PZ&B Staff Combination Memorandum: Landmarks Preservation Commission and Town Council

SUBJECT: ZON-24-0032 (COA-24-0010) 228 SEASPRAY AVE (COMBO)

MEETING: AUGUST 21, 2024, LPC
SEPTEMBER 11, 2024, TC

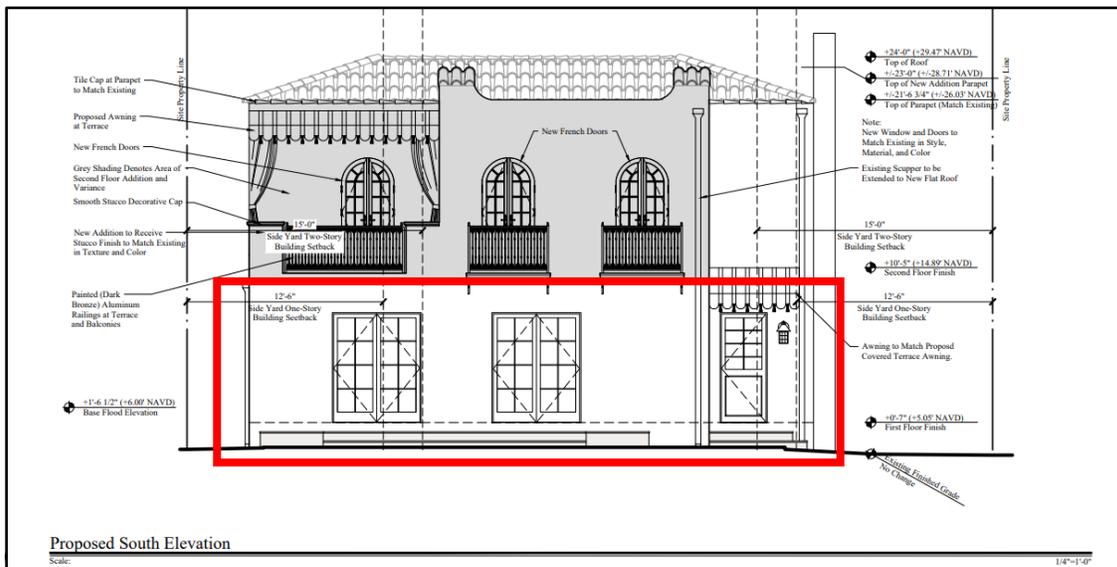
The new second-story addition and covered terrace are proposed on the south (rear) elevation of the structure. Although the residence has two stories, at the rear there is a one-story volume. The new addition and terrace will be located above it. Four windows will be removed on the second floor to accommodate the addition. A flat roof design with a decorative parapet with clay barrel tile caps which is consistent with the architectural style of the residence is proposed. Four (4) sets of arched wood French doors with divided-light patterns are proposed, one (1) them will be added to the existing exterior wall of the structure. A stucco finish will be installed to match existing ones. Two (2) projecting balconies with dark bronze aluminum railings will be located on the south side of the addition.

Directly west of the addition, a new covered terrace will be created. It will include a new awning with a forest green striped pattern as well as dark bronze aluminum railings and balcony walls.

The property does not conform with existing lot coverage, setback, and cubic content ratio (CCR) requirements. This is not uncommon for historic structures from the 1920s that were not built under the current zoning regulations. The covered terrace as part of this application does require a side (west) yard setback since it follows the existing side yard setback of the residence (2'-5") which does not meet the minimum 15'-0". Adding square footage to the second floor of the residence also triggers the need for a CCR variance, but not a lot coverage increase, since the existing structures already exceed the maximum CCR of 4.39—it is at 5.81, as outlined in the table below:

Overall, the design of the new addition and covered terrace is compatible with the Mediterranean Revival structure. Although a lower parapet height could achieve a greater level of differentiation from the existing structure, the proposed parapet with decorative elements and tile caps also satisfies this historic preservation objective.

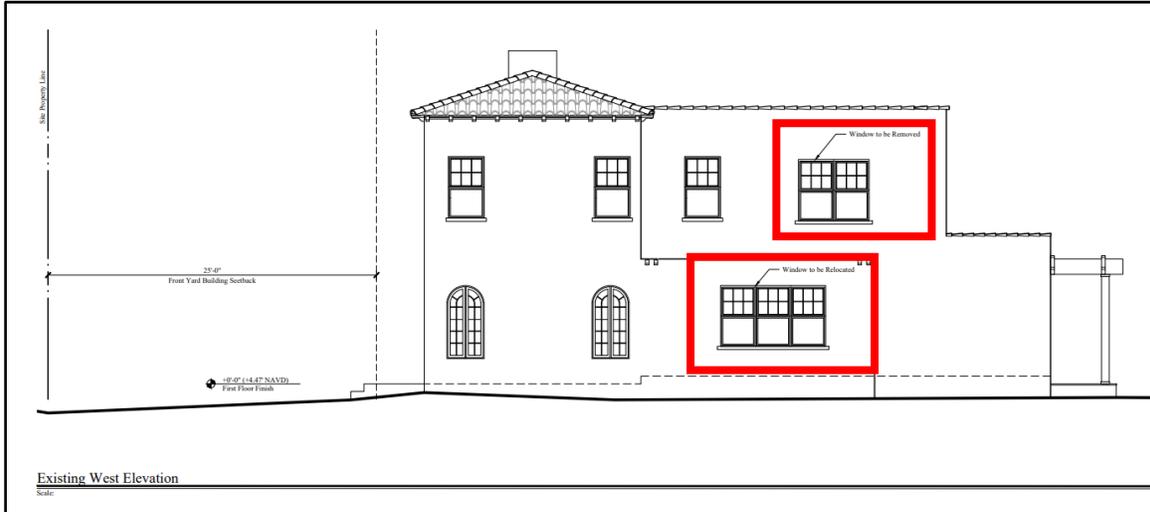
metal sash window and one (1) white metal fixed window (that replicates the appearance of a sash

window) with greater spacing between them. One of the removed windows will be reinstalled on the first-floor façade. Additionally, a triple window on the ground floor will shift slightly to the north to accommodate an adjusted floorplan.

From a historic preservation perspective, original openings should remain. However, the proposed changes will be minimally visible from the street. Staff recommends that the Commissioners discuss whether the new windows should be wood frame to match the existing fenestration.
